Site Plan  
 Village of East Troy,  
 Wisconsin Version: March 10, 2025

TO: Paul Van Henkelum, PE, PLS (Teronomy Builders)  
FROM: Orrin Sumwlat, AICP Planning Consultant  
DATE: October 3, 2025  
RE: Review Comments  
Teronomy Self-Storage: PDD Amendment - FDP

Foth has reviewed the revised materials for the Teronomy Self-Storage Planned Development District (PDD) Amendment – Final Development Plan (FDP) application received on September 15, 2025, for the property located on Honey Creek Road bearing Tax Parcel No. RA491500002. Review comments are as follows:

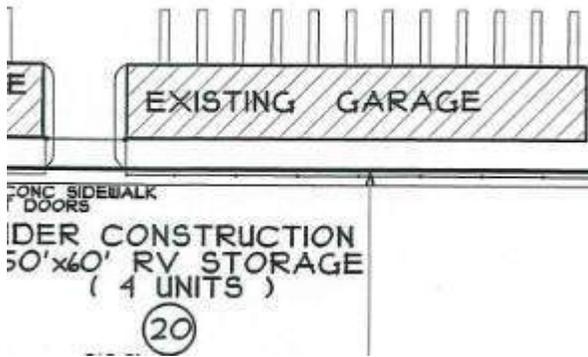
4. The Architectural Site Plan doesn't depict angled parking spaces east of Building #12, while the Engineer's Site Plan does. Please rectify this discrepancy.

- Please depict the no-parking striping that was previously required at the end of the existing garage located north of the cross-access to the adjacent Honey Creek Lofts property. Apparently this was required to ensure a fire truck can make the turn from one property to another.

Complete

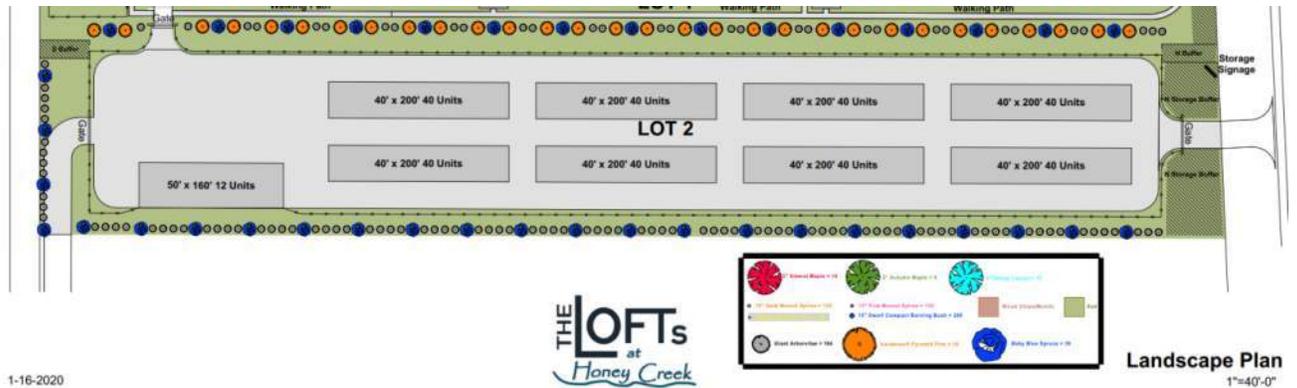
- Please submit new turning movements to demonstrate how Village emergency vehicles will be able to maneuver through the site, including the cross-access to the adjacent Honey Creek Lofts Apartments development.

Incomplete. The document labeled "The Lofts Site Plan Turning Radius" appears to be a copy of the Site Plan and doesn't depict the requested turning movements. Please submit a revised plan addressing this.

6. The approved site plan included turning radius. We included a copy in this resubmittal.

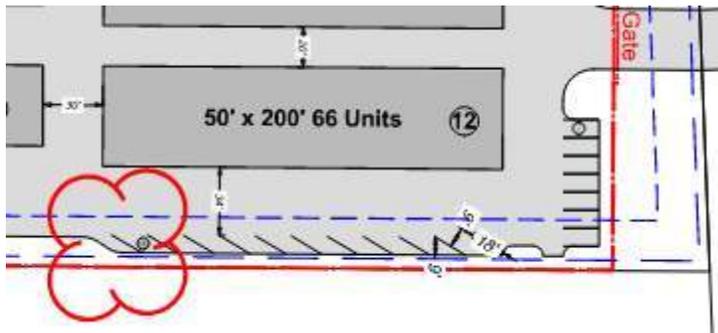
13. Please provide colored elevations and/or an artist rendering for the proposed buildings.

Complete

2a. The original approved renderings are provided in this submittal showing elevations of the building in color. We have also included a computer-generated drawing showing the modification of the color scheme to be copper, black and dark grey to blend in more with the adjacent apartment building.

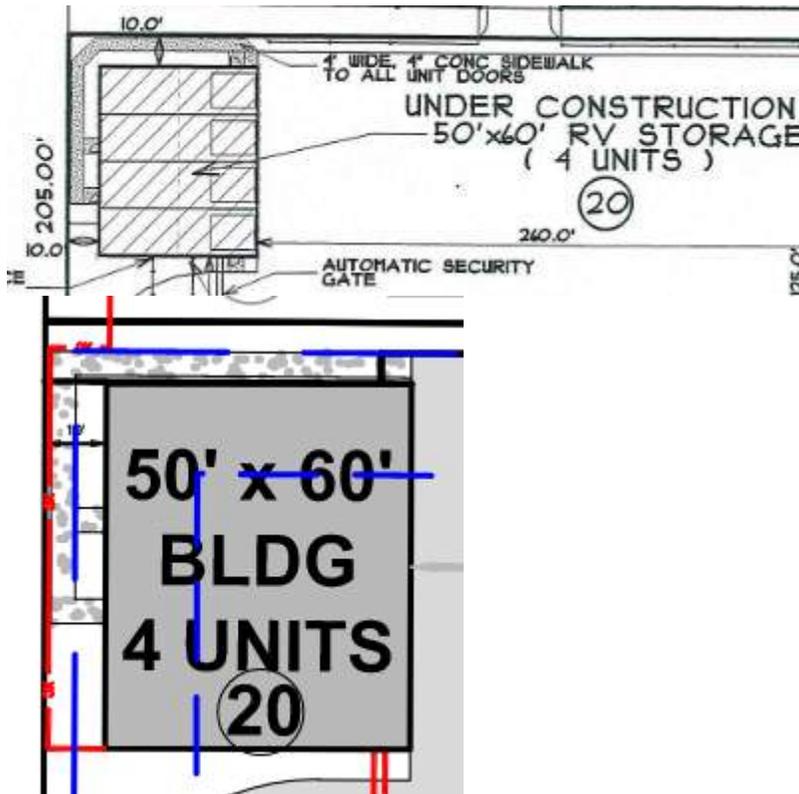
19. Foth and staff recommend a decorative metal fence (steel or aluminum) along the north and east property lines like the fencing depicted below. We are ok with chain-link fencing along the south and west property lines.

19. A black chain link fence was approved by the Planning Commission for this site in the original submittal. The owner has ordered for this project and we are waiting for a building permit to start construction. We feel the landscaping will provide visual screening and will enhance the street scape of executive drive.

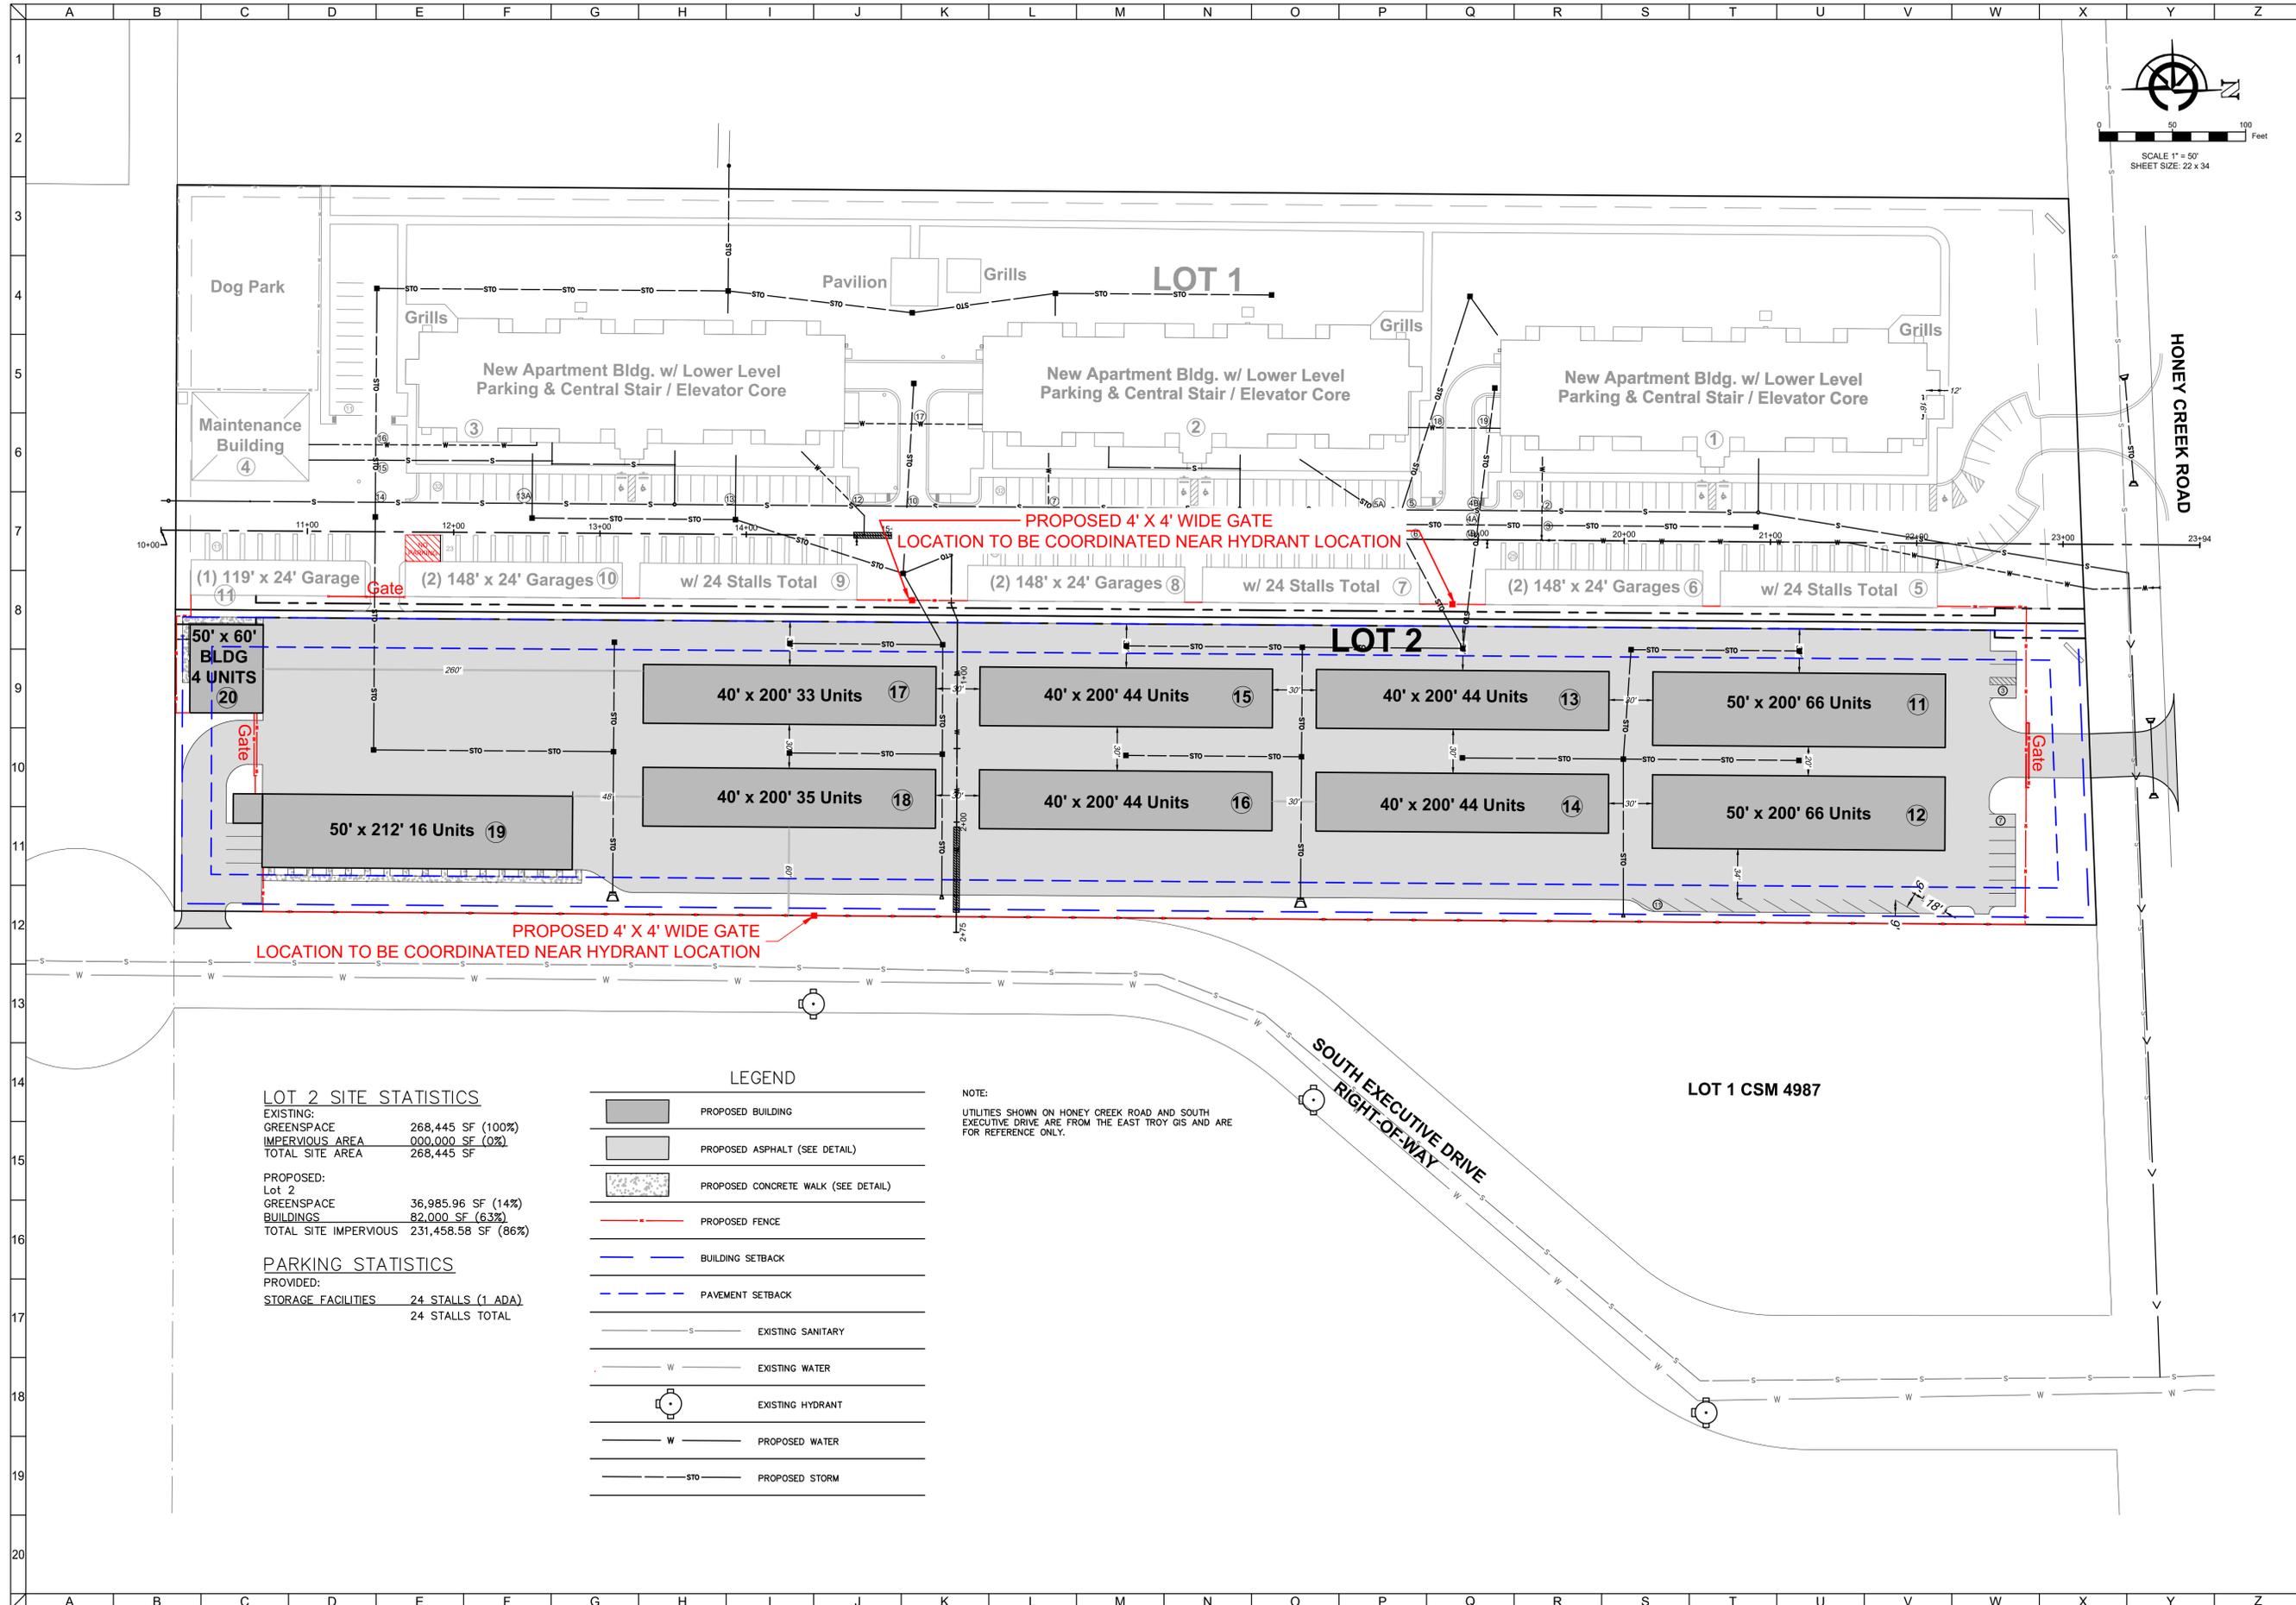
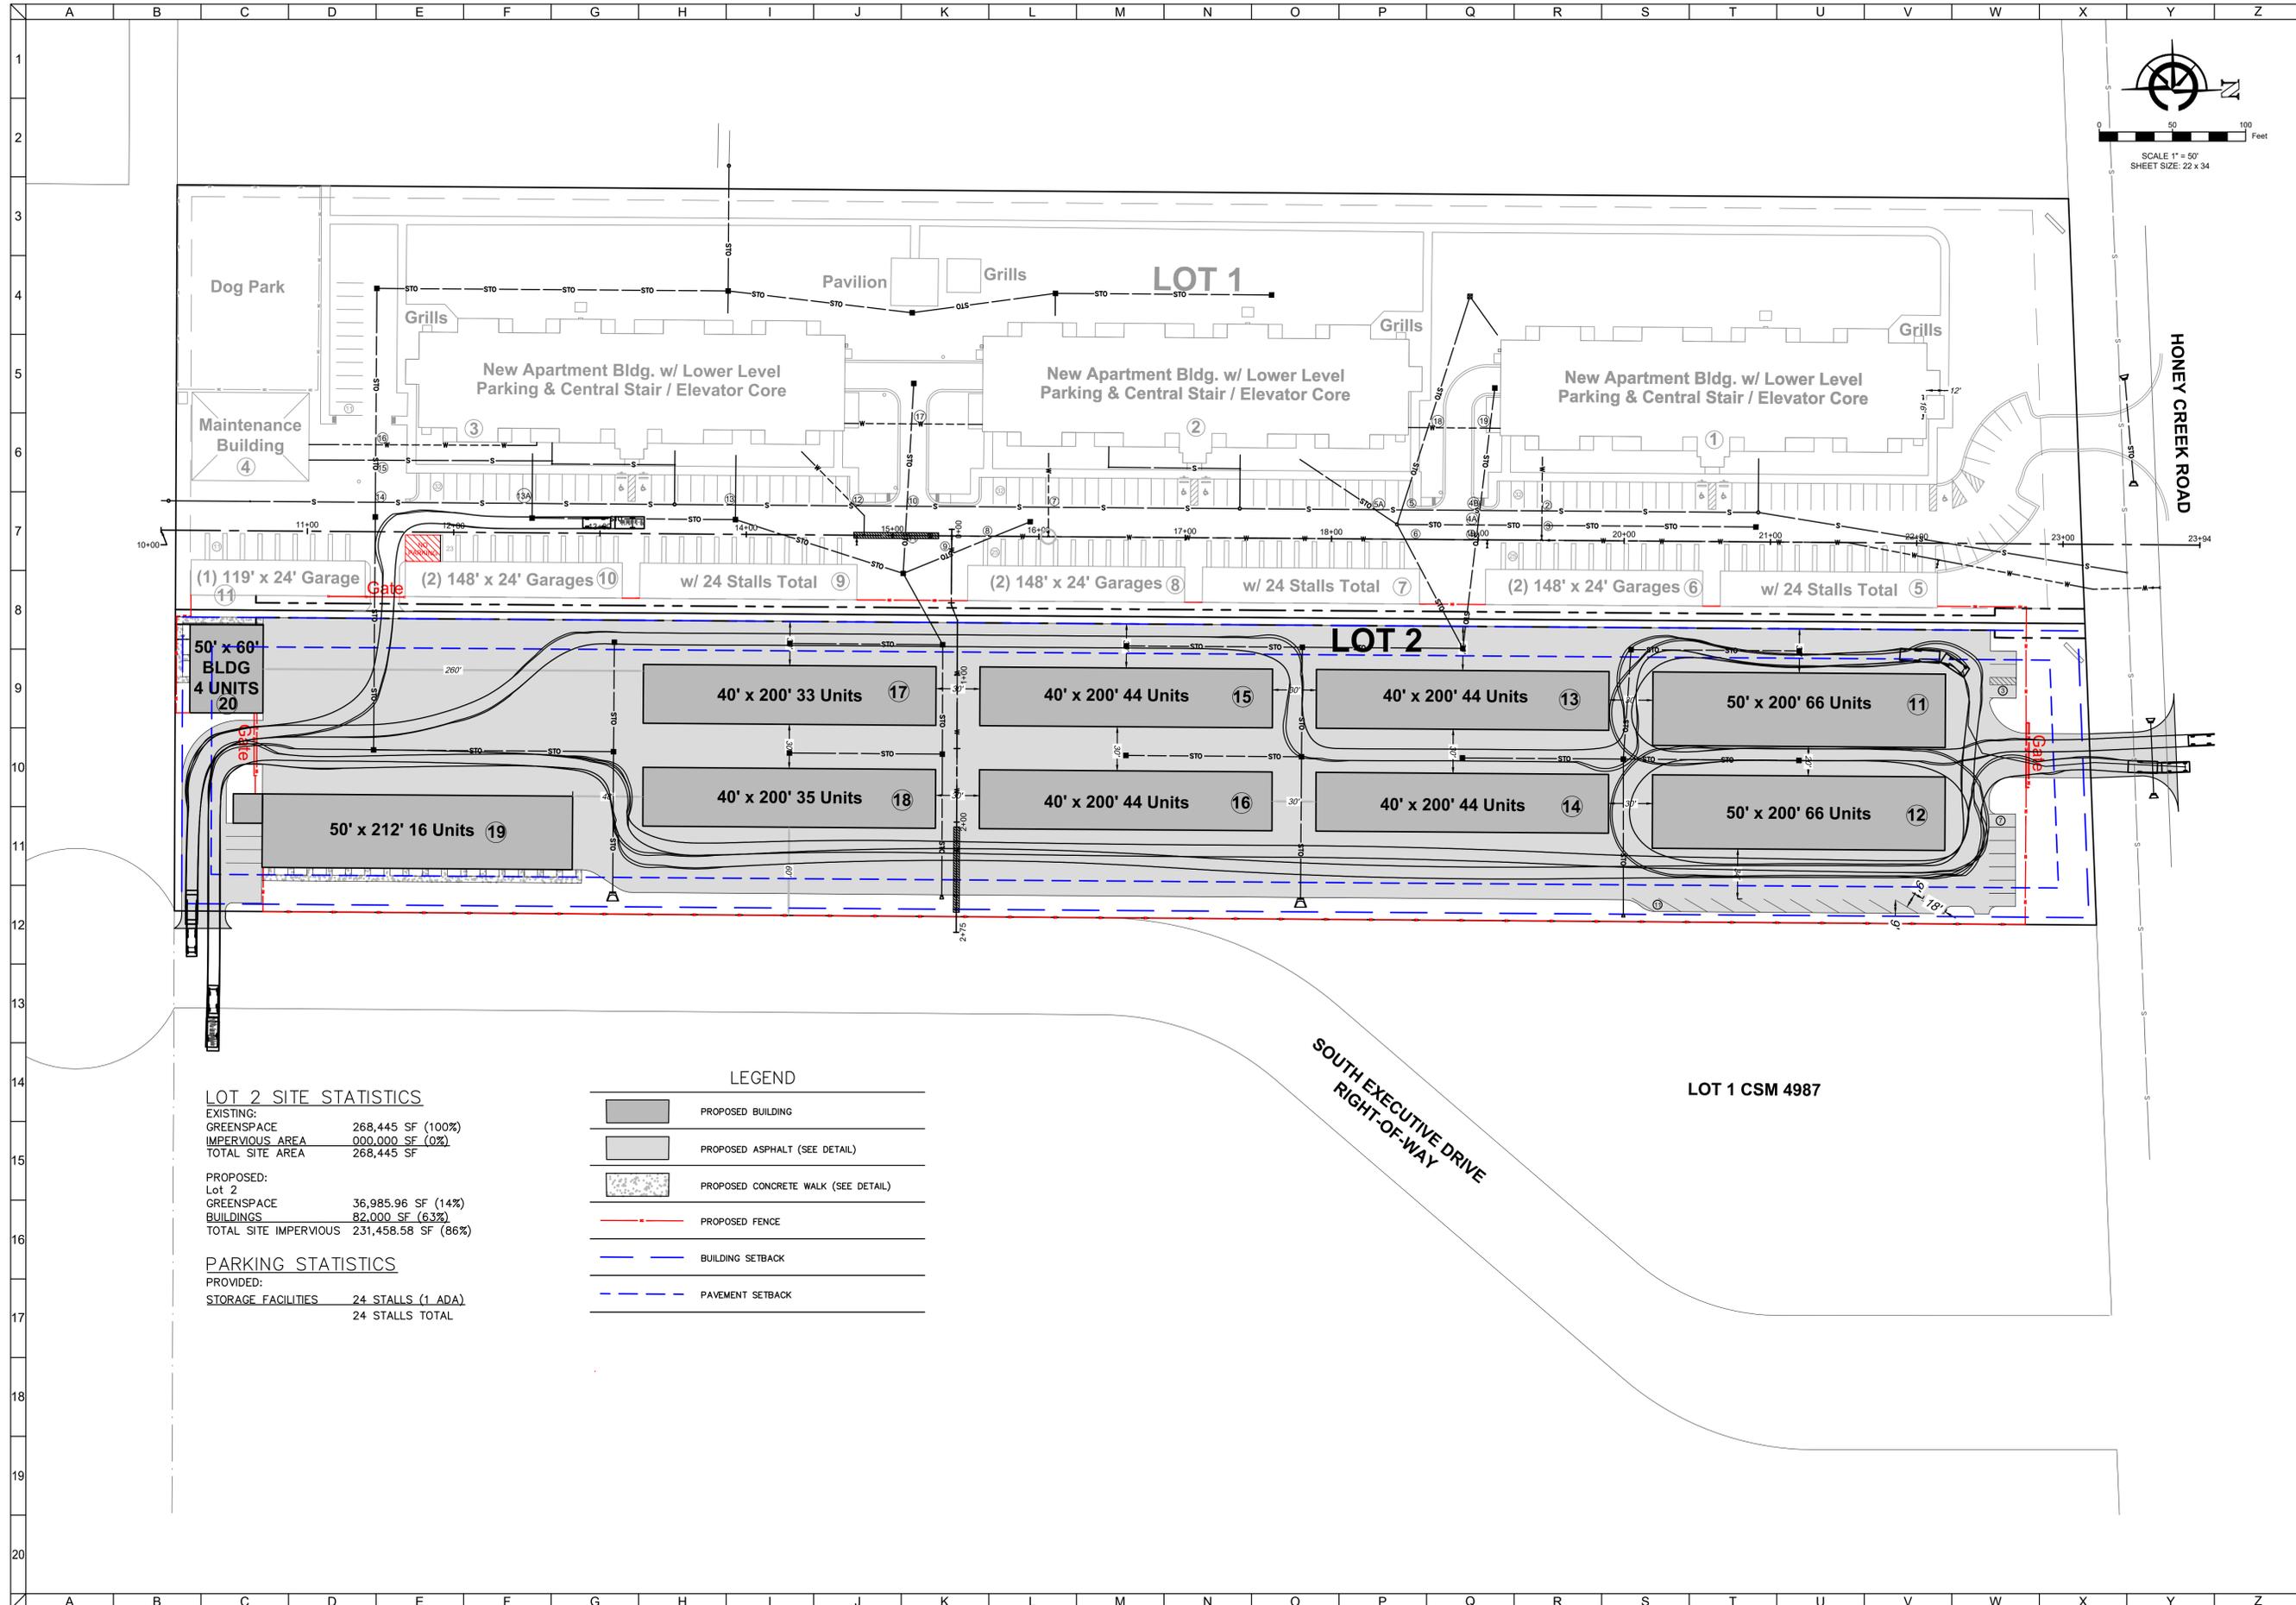
1. The proposed sidewalk on the south side of Building #20 doesn't meet the minimum 5-foot pavement setback. Please amend your plans accordingly to correct this encroachment.

2. Please depict the fire hydrants and access gates for the Fire Department on the Site Plan and label them accordingly.
3. What is the grade in the vicinity of the Fire Department access gates? There appears to be an approximately 4' change in grade. How will Fire Department personal safely navigate this?
4. Please add the STO, W, and turning movement symbols to the legend of 1901420-Site Plan-10-09-2025 document.

1. The location of Building #20 was discussed and approved prior to this current request. I am not sure why this location came up again. When we were laying out this building we were trying to get as much room as possible on the north side of Building 20 to accommodate, not only the larger RVs and boat trailers, but to have an area where emergency vehicles could turn around. We added a people door at the rear of the two middle units (thus the need for the sidewalk), and a side door on the outside units, so they would have the ability to access their stored equipment without have to remove their larger equipment (RV, boat). This is a planned development that is taking into a lot of factors. This building is in the southwest corner of the Self-Storage complex and is screened from the apartment building by the garages and a berm to the south. We think providing access with a sidewalk to access the back of these two units is a better design than making the building 10' wider and providing the access doors next to the garage doors does not work as well as where we show it on our proposed site plan. If the Planning Commission has a problem with the sidewalk and its location, I would be interested in their comments..

2. I am attaching a new site plan, showing the location of 3-4'x4' gates that will provide the fire department. This will provide access to the fire hydrants in the Loft's Development and to one hydrant located on Executive Drive. There are also 3 gates that the fire department will have access to with fire hydrants located in the vicinity of the gates. This was discussed with the fire chief.

3. The gates are to provide the fire department the ability to access the hydrants for fire hoses. We are not anticipating the need for any vehicle access though these gates. We don't think the 4' difference in elevation will be a problem.

4. The items requested have been added to the site plan.
5. I have attached the lighting plan that was originally approved in the FDP request. There have been minor changes to the plan that may require a change to the lighting plan so we are in the process of updating the plan. We expect to be able to get you a updated plan tomorrow. If you not able to review the plan, we would ask for approval subject to staff review of the modified plan. The approved plan and the revised plan will have full cut-off fixtures.
